## **IN THE DRAWINGS:**

## REMARKS

Sheets of revised Figures 1-3.

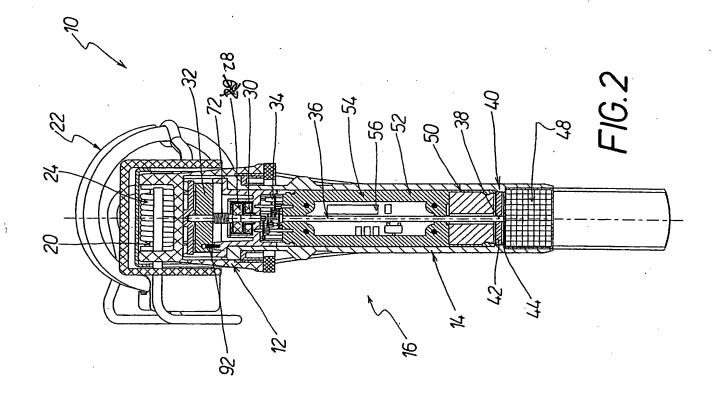
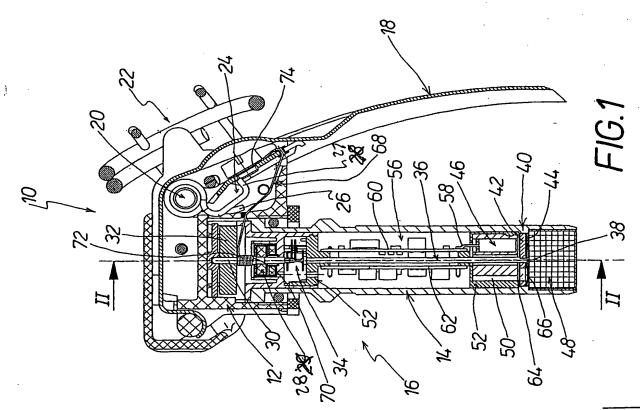
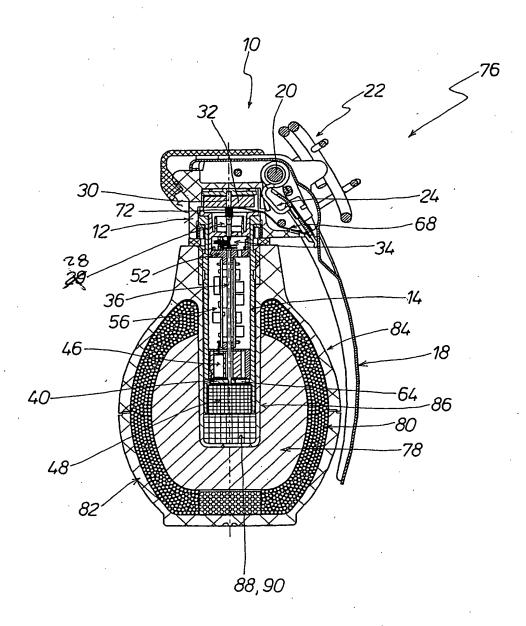
With regard to the Examiner's objections to the drawings under 37 C.F.R. §1.83(a), applicants herewith enclose two (2) Replacement Sheets incorporating the minor corrections, which have been implemented thereto by the replacement of "29" by –28-- and insertion of the reference numeral 27, which is directed to the second end portion of the tensioning spring 24, as shown in red on the Annotated Drawing Sheets. In this connection, applicants have implemented a minor amendment to the specification correcting the reference numerals in the appropriate paragraph, wherein this second end portion has been inadvertently identified as "28", rather than --27--.

The minor amendments, which have also been implemented to the Listing of The References, should clearly meet the Examiner's requirements without the introduction of any new subject matter. Corresponding revisions have been implemented to the drawings on file, as shown on the enclosed Annotated and Replacement Sheets, thereby meeting all of the formal requirements concerning the drawings and specification.
